FTC-TR-70-8

**CATEGORY II
PERFORMANCE AND
FLYING QUALITIES TESTS
OF THE HH-53C HELICOPTER**

ASD Addendum to FTC-TR-70-8, H-53 Performance/Flying Qualities Tests

This report is a part of and should remain attached to FTC-TR-70-8, "Category II Performance and Flying Qualities Tests of the HH-53C Helicopter". Paragraph numbers below correspond to the recommendations in the AFFTC Technical Report.

Figure 1

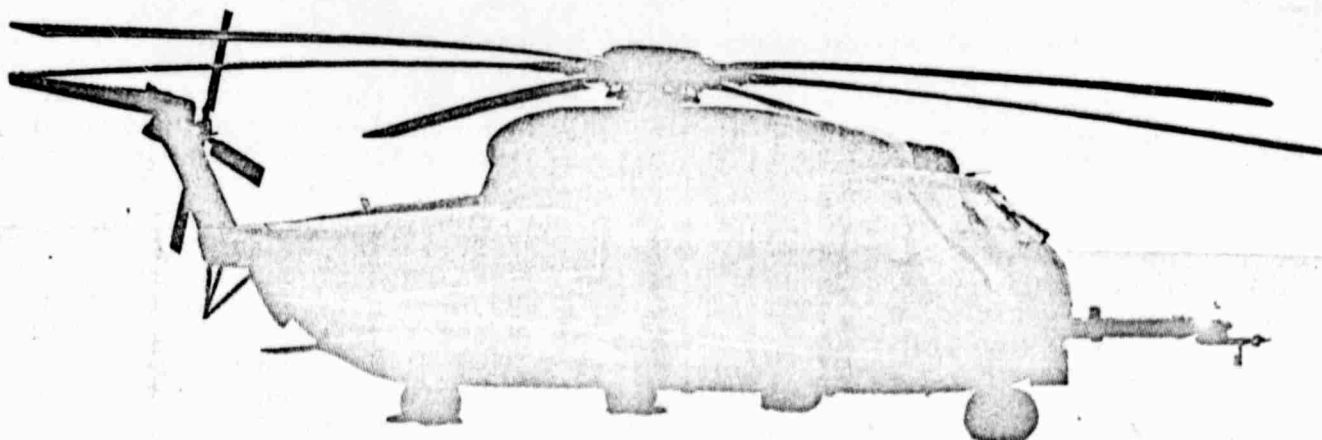
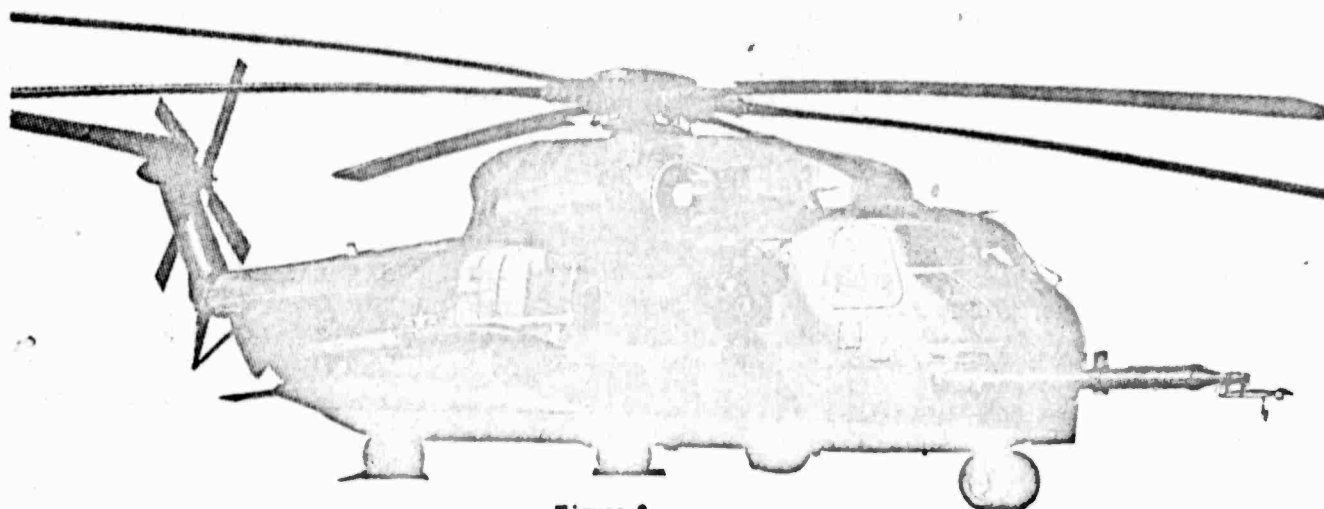
During the level flight portion of the test program a limited evaluation was conducted with both engines equipped with engine air particle separators (EAPS) to determine the effects on performance. The EAPS was designed to remove foreign particles from the engine inlet air. For the condition investigated with the EAPS installed, power-required increased as much as 9 percent. A typical EAPS installation is shown in figure 1; figure 2 shows the helicopter not so equipped.
